FORESTSIDE TOWNHOUSES

TENDER ADDENDUM # 5

Date: January 8th, 2021

JAP Project No: 19066

Date Plotted	ND	Date	Jan 08 2021
Drawn By	JW	Scale	1 : 100
Checked By	JW	Revision Number	
Job No.	19066	Sheet No.	S-101A

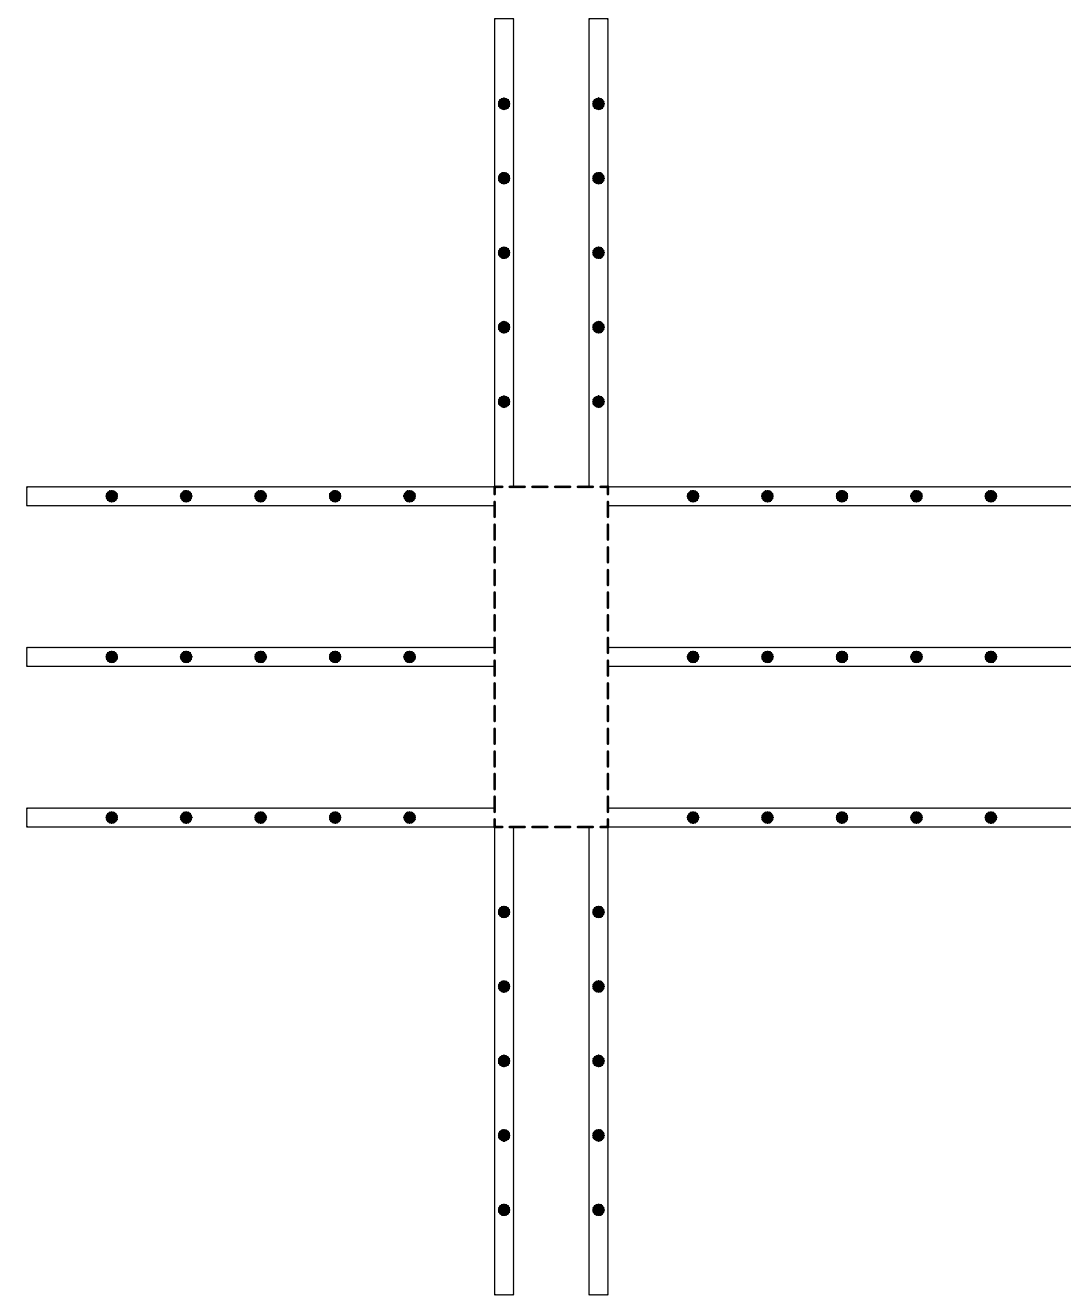
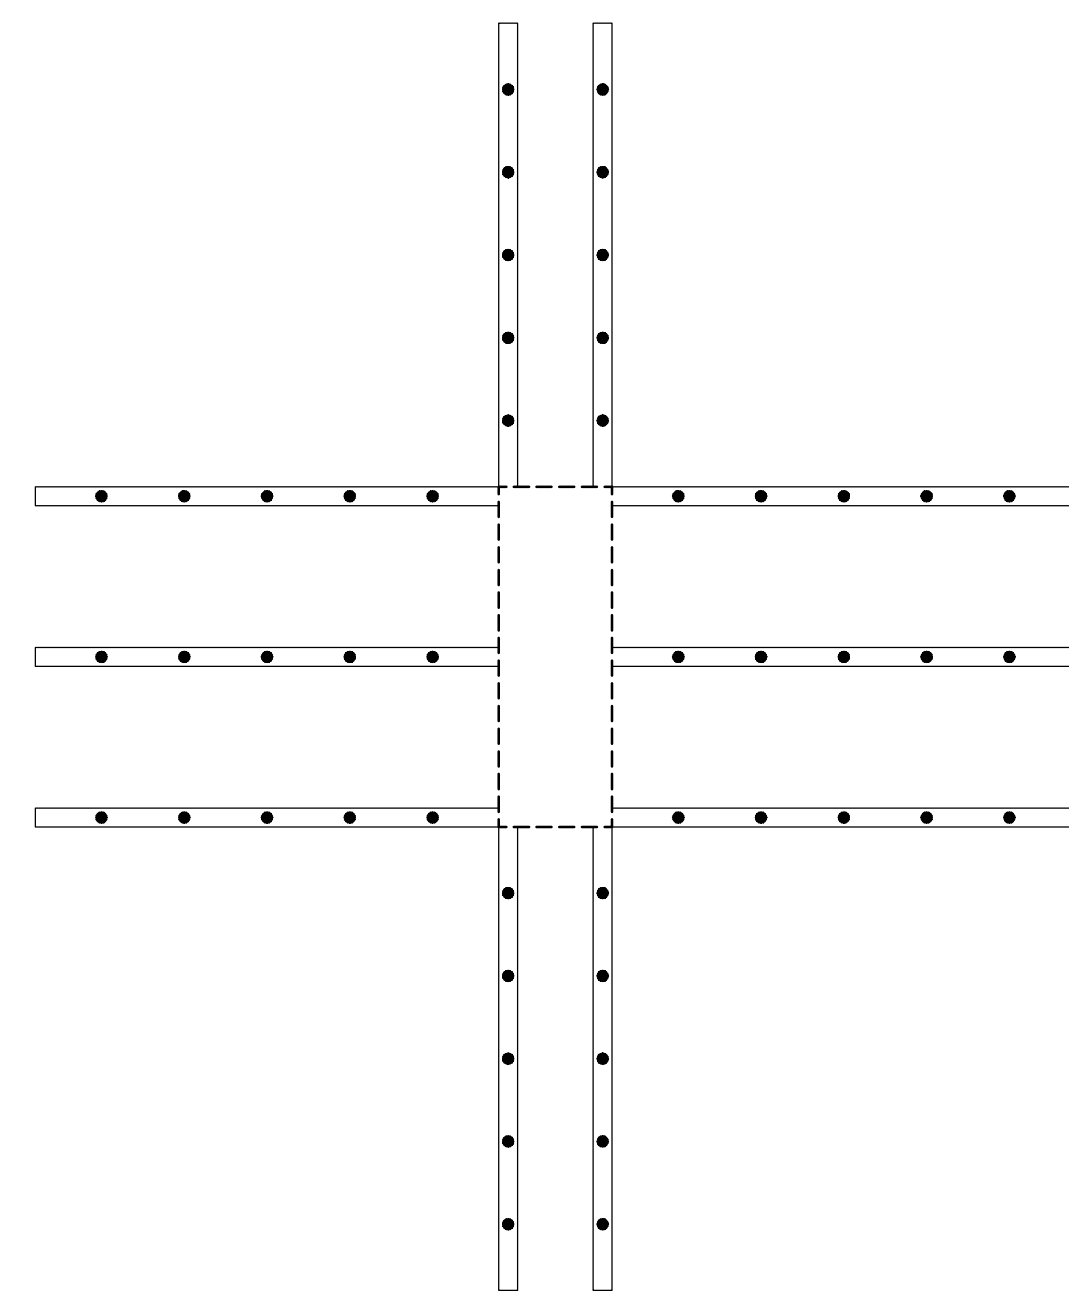
- 1.1 **Refer to Drawing S-101A "P1 UNDERGROUND"**
 - a) Added label for HSS at overhead door.
- 1.2 **Refer to Drawing S-102A & B "GROUND FLOOR"**
 - b) Clarified labels for stud rail details.
- 1.3 **Refer to Drawing S-103A & B "2ND FLOOR FRAMING PLAN"**
 - c) Labelled rebar for 200 slabs as bubbled.
 - d) Updated walls to match architectural as bubbled.
